**SUB:** NIC Components PCN & EOL Notifications

**RE:** Product Change Notification

**Product Type:** Surface Mount Resistors

**NIC Series:** NRC and NRCS Series

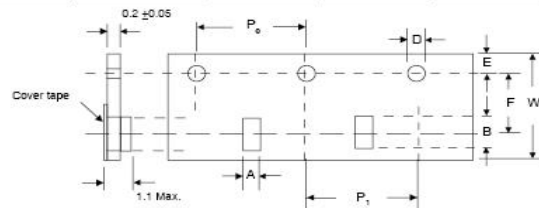
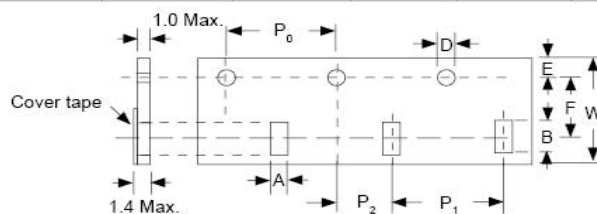
THE FOLLOWING IS NOTICE THAT THE TAPE & REEL CARRIER MATERIAL, REEL QUANTITY AND TAPING DIMENSIONS FOR THE 1210 CASE SIZE **NRC25** AND **NRCS25** SERIES PARTS ARE BEING CHANGED AS DESCRIBED BELOW.

**CARRIER MATERIAL:** CHANGE FROM EMBOSSED PLASTIC TO PAPER

**REEL QUANTITY:** CHANGED FROM 4,000 PIECES TO 5,000 PIECES

**CARRIER DIMENSIONS:** See below

**Discontinued Embossed Plastic Carrier**

A	B	D	E	F	P <sub>0</sub>	P <sub>1</sub>	P <sub>2</sub>	W	Qty per 7" Reel
3.0 ± 0.10	3.5 ± 0.10	1.55 ± 0.05	1.75 ± 0.10	3.50 ± 0.10	4.0 ± 0.10	4.0 ± 0.05	N/A	8.0 ± 0.10	4,000

**New Paper Carrier**

A	B	D	E	F	P <sub>0</sub>	P <sub>1</sub>	P <sub>2</sub>	W	Qty per 7" Reel
2.85 ± 0.20	3.50 ± 0.20	1.5 ± 0.10	1.75 ± 0.10	3.50 ± 0.05	4.0 ± 0.10	4.0 ± 0.10	2.0 ± 0.05	8.0 ± 0.20	5,000
